Re: TAC Resubmission Reis Farm Assessor's Map 255, Lot 5 305 Peverly Hill Road Altus Project No. 5411

Attached please find revised plans for the above referenced project. Changes include:

Assessor's Parcel 255, Lot 5 ISSUED FOR TAC

SHEET NUMBER:
		C-3

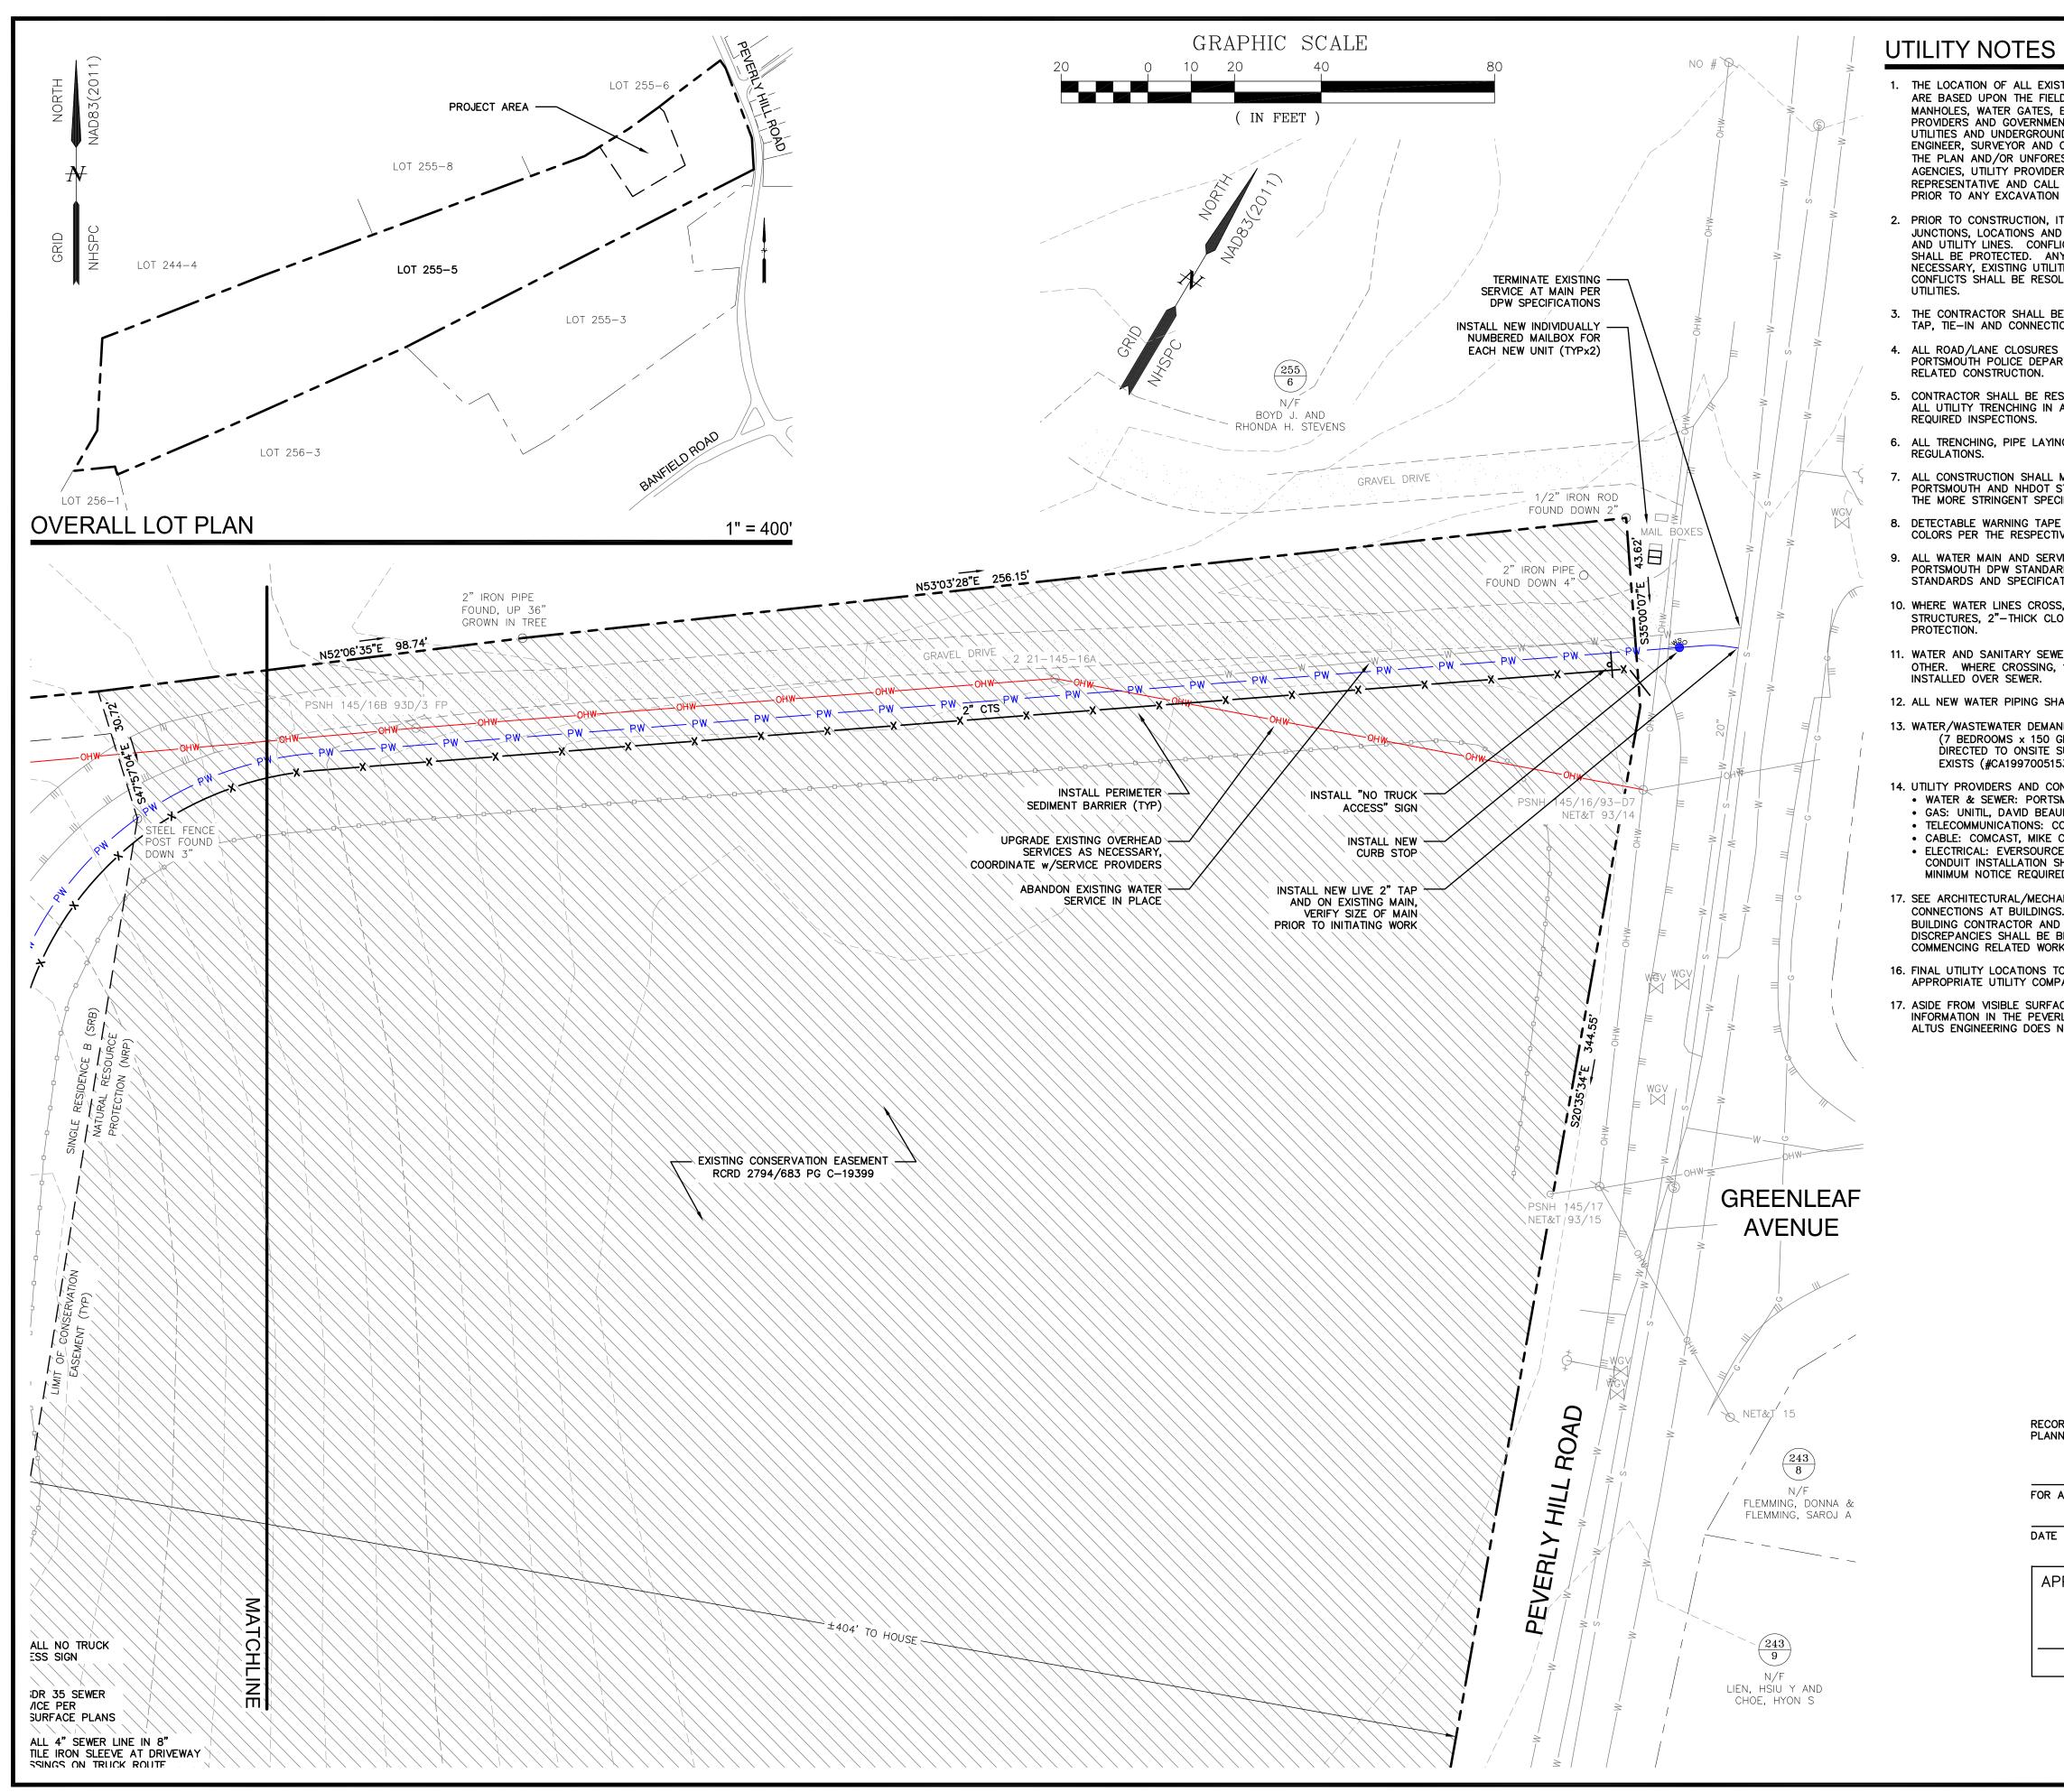
- Rerouting of the proposed water line replacement and updating the pipe to CTS.
- Revisions to the septic system layout.
- The addition of pipe sleeves where the septic lines cross truck routes.
- Two "no truck access signs" to restrict trucks from the northerly driveway.
- Unit numbers per DPW and corresponding mailboxes on Peverly Hill Road.
- A turning movement analysis plan for fire truck access.
- Inclusion of plans for the ADU which include details on fire prevention.
- Removal of the existing connector between the ADU and barn.
- Various minor "housekeeping" items.
